URGENT: FIELD SAFETY NOTICE

MSA/2014/001/IU

| SUBJECT | Preventive Action: - Replacement of MAQUET STANDOP VOLISTA spring arms |
| DEVICES CONCERNED | <u>MAQUET VOLISTA 400 equipped with spring arm:</u> Part Numbers / Serial Numbers: The complete list of potentially affected devices is provided in a separate document. |

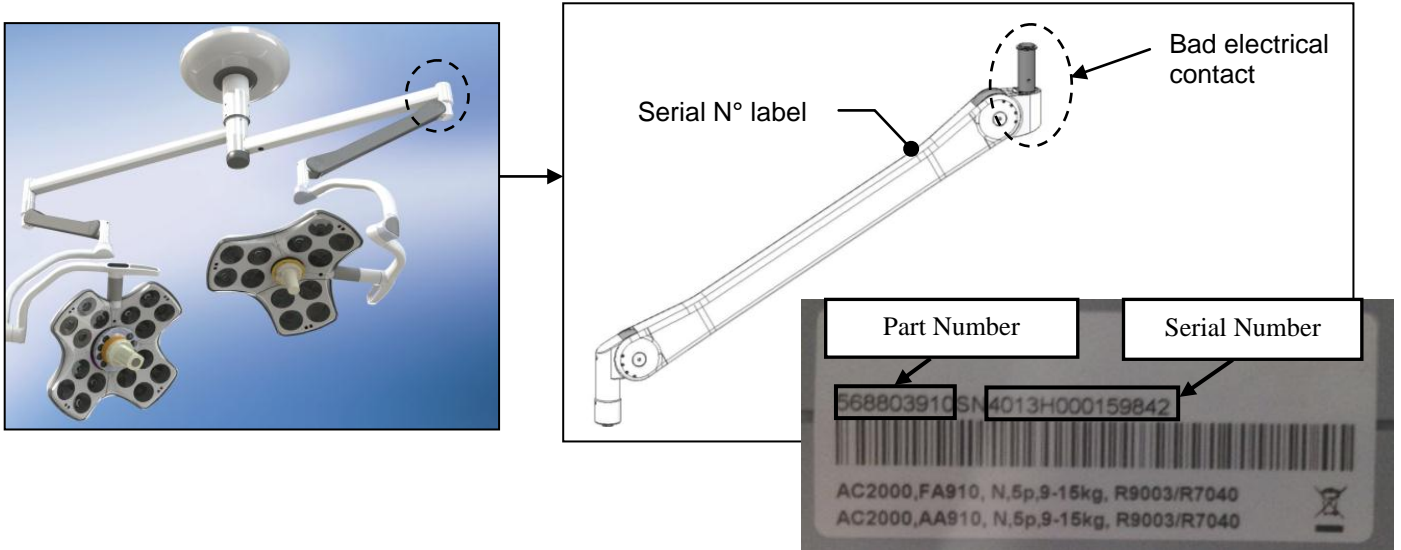
MAQUET identified that some STANDOP VOLISTA spring arms were defective.

The failure affects the 5-pole plug connectors and can generate a gap, allowing a potential electrical disconnection during use of the device. Depending on the width of the gap, a malfunction may not be detected during the installation activities.

A defect on the 5-pole plug connector, in case it is not detected during the installation activities, may result in a sudden extinction of the light during an operation.

Although MAQUET estimated that there is a low probability that the situation causes harm to a patient, MAQUET decides to replace all the potential defective spring arms.

Please immediately verify on the product label that your STANDOP VOLISTA light is in the scope of this Field Safety Corrective Action, and contact your local MAQUET office or distributor in order to organise a replacement.
